SUBJECT: Comments on the April 16, 2020 Draft Environmental Impact Report for proposed “Hollywood Center” project. State Clearinghouse Number SCH 2018051002.

The Department of Conservation’s California Geological Survey (CGS) received the April 16, 2020 Notice of Completion and Availability of Draft Environmental Impact Report (DEIR) for the “Hollywood Center” development project, located near Yucca Street, Argyle Avenue, Ivar Avenue, and Vine Street, in the Hollywood Community Plan area of Los Angeles, CA 90028. This letter conveys comments from CGS regarding geologic and seismic conditions affecting the site, including new information not addressed in the DEIR.

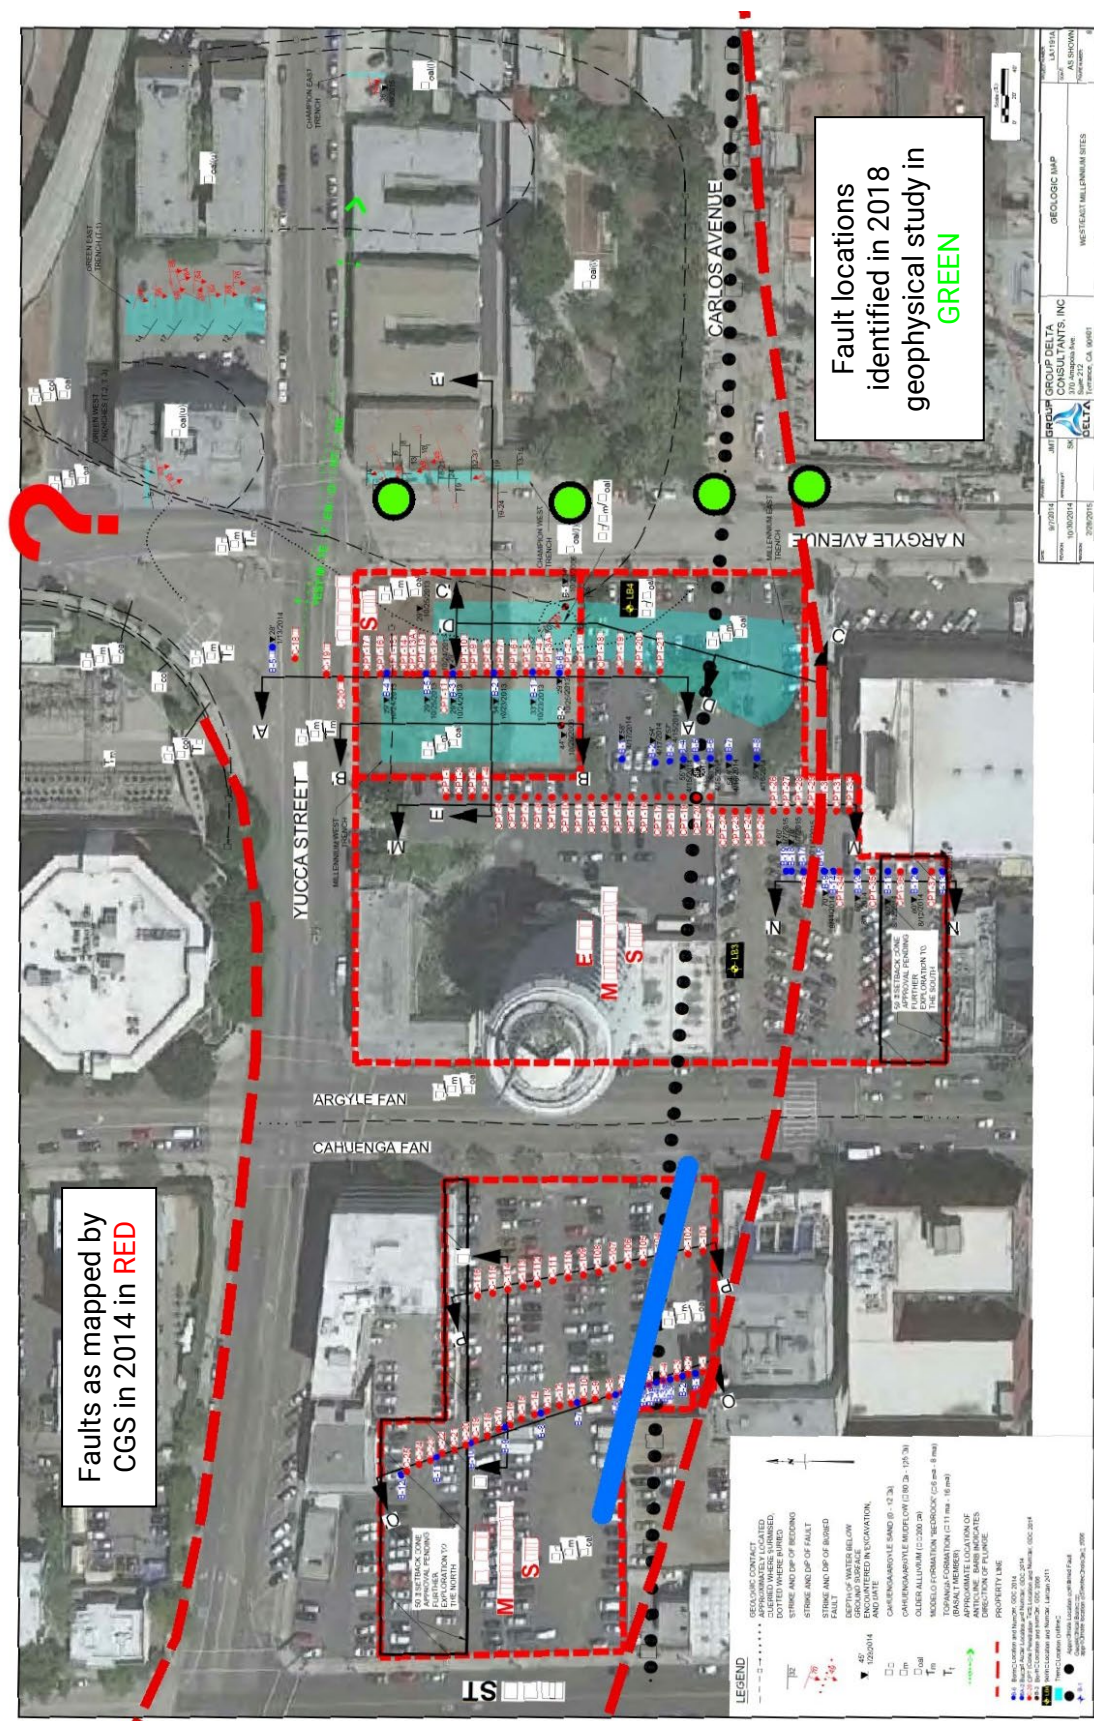
- 1. Fault traces depicted in CGS's 2014 Hollywood Fault Map do not appear in Appendix G-1's figures of the project site** where locations of their subsurface investigations are presented. Therefore, we attach a figure showing both the location of traces as shown on the 2014 Hollywood Fault Map and the areas of investigation reported in Appendix G-1 (**Figure 1**). (DEIR Appendix G-2 shows the location of the fault trace at a lower level of resolution.) We note below that Figure 1 reflects new information indicating the active fault, which was not cleared by either the 2014 trench or the other investigative techniques reflected in Appendix G-1.

- 2. The 2020 USGS study, and other studies that post-date CGS's 2014 Hollywood Fault Map, strongly suggest an active strand of the fault crosses the project site.** CGS considered the 2020 USGS study in light of other studies conducted after the 2014 Hollywood Fault Map. These studies are listed at the end of this letter and, for your convenience, are also available on CGS' FTP server ([FTP Link](#)). These studies, conducted east of the project site, postdate the studies included as Appendix G-1 to the DEIR, and are therefore new information of importance to public safety. These studies strongly support the presence of an active southern fault strand entering the eastern Hollywood Center property in the vicinity of the alley at Argyle, south of the

3. **The fault trench excavated in 2014 did not clear the entire site of active faults.** Based upon review of the information presented in Appendix G-1 of the DEIR, the GDC trench on the east property did not completely expose the base of the Holocene-age geologic section across the north-south extent of the site and therefore cannot be considered to exclude the presence of an active fault at or near where it is depicted in CGS's 2014 Hollywood Fault Map, or in the more recent studies mentioned above.

In conclusion, further assessment of the southern strand of the Hollywood Fault, following, for example, best practices outlined in CGS Special Publication 42 as discussed above, is important to adequately understand seismic risks of the proposed development in light of recently available information.
